RCSC Middle School **Natatorium HVAC & Lighting Upgrade**

Project # 2023.0011

05-20-2024

ADDENDUM NO. 01

TITLE
Interior Finish Plan
&
Details
SHEET

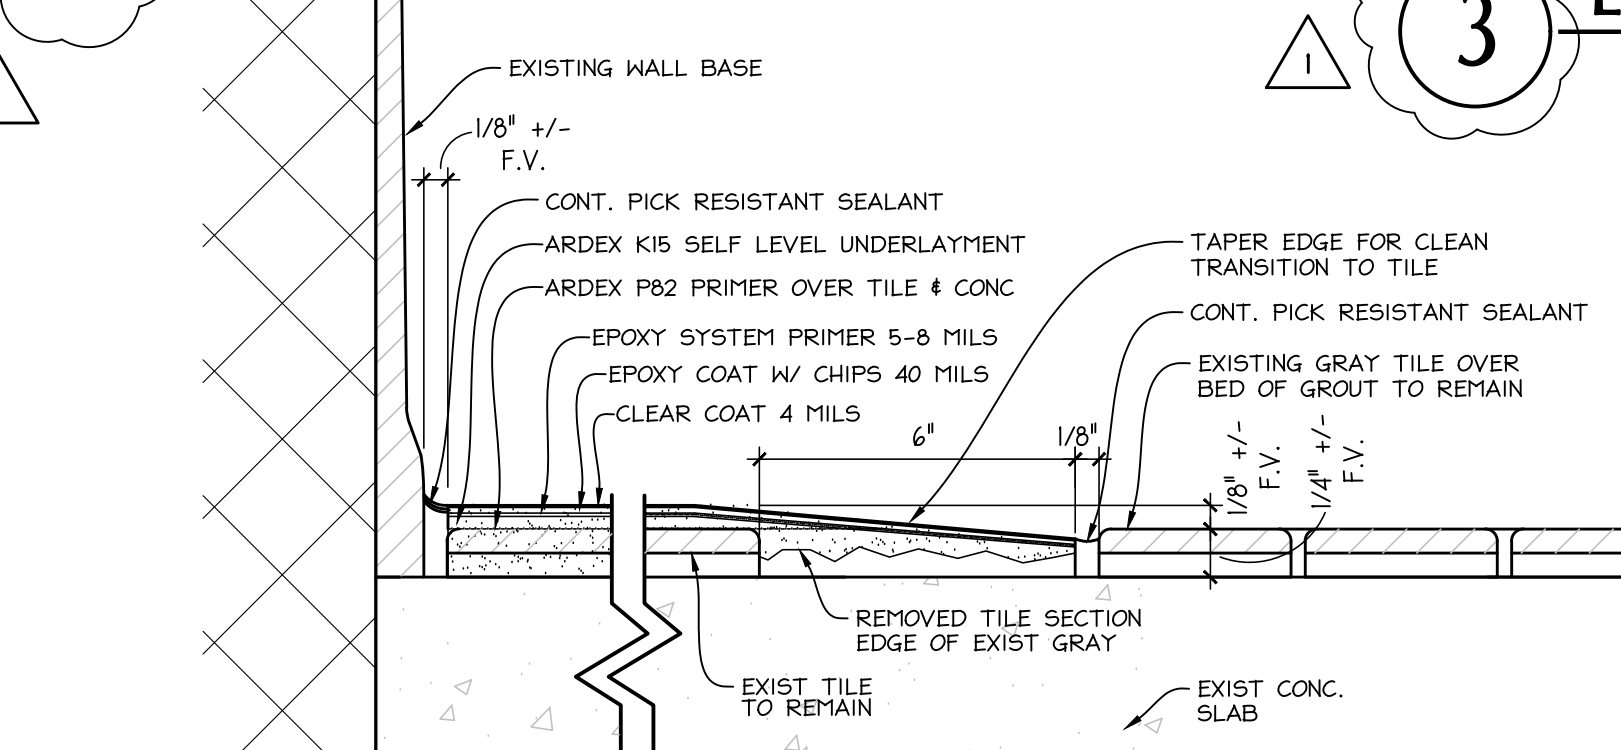
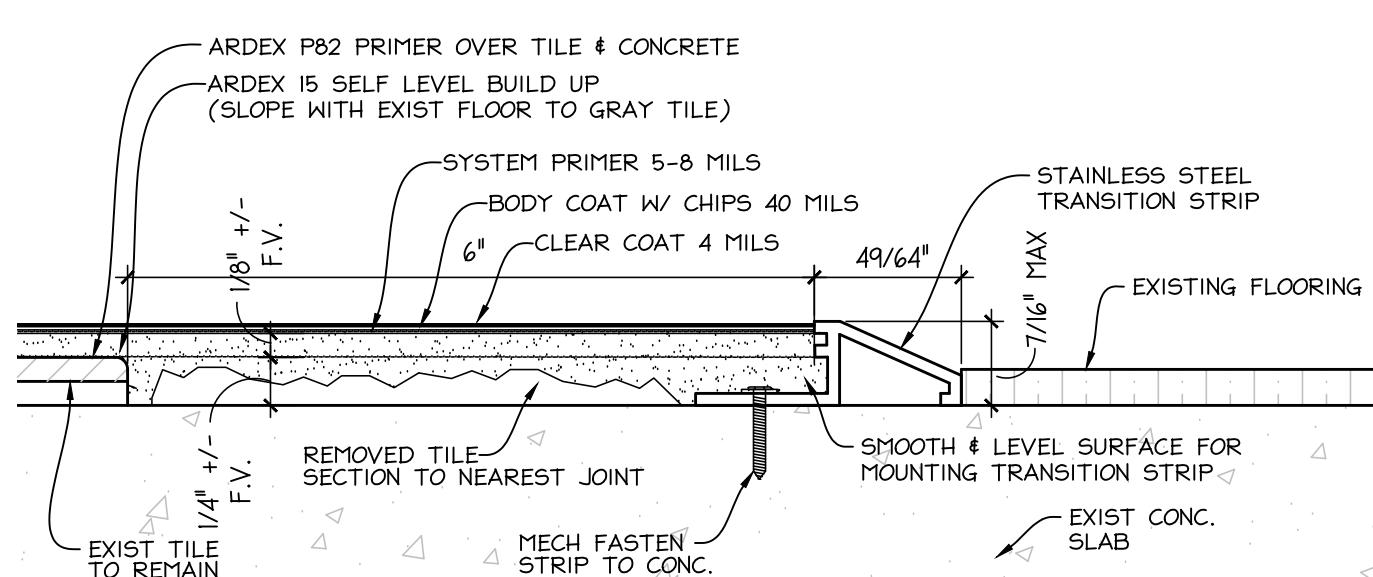
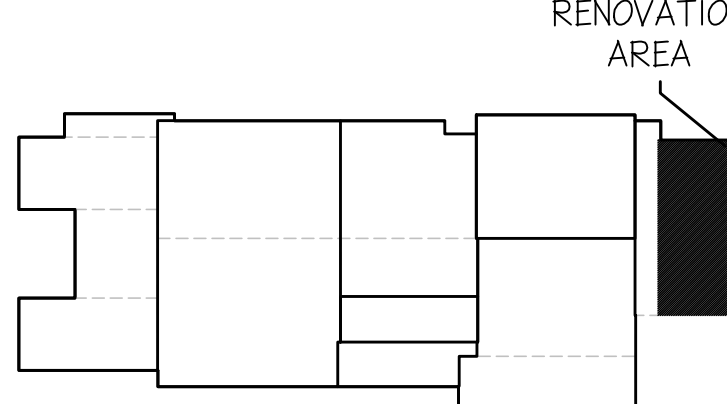
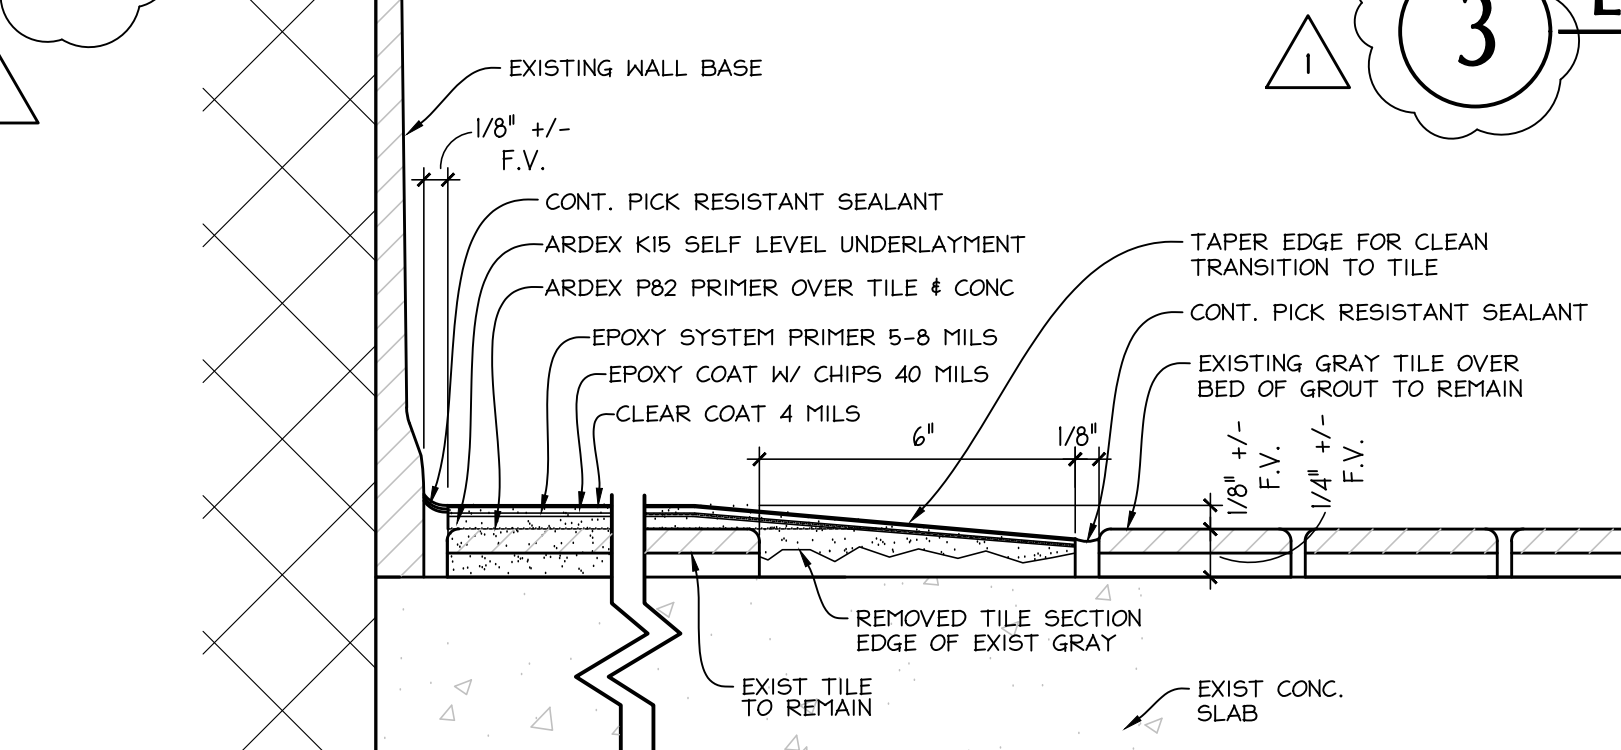
Item: **A-1.10**
Location: A11.1 Interior Finish Plan & Details
Description: Replace drawing dated 05-01-2024 with drawing marked Addendum 01, dated 5-20-2024

1. Updated Details 2 / A11.1, 3 / A11.1, 4 / A11.1 to reflect Epoxy floor finish over existing tile.
2. Added Detail 5 / A11.1.
3. Updated Finish Schedule with Colors and Notes
4. Revised notes 11.01, 11.07, 11.08
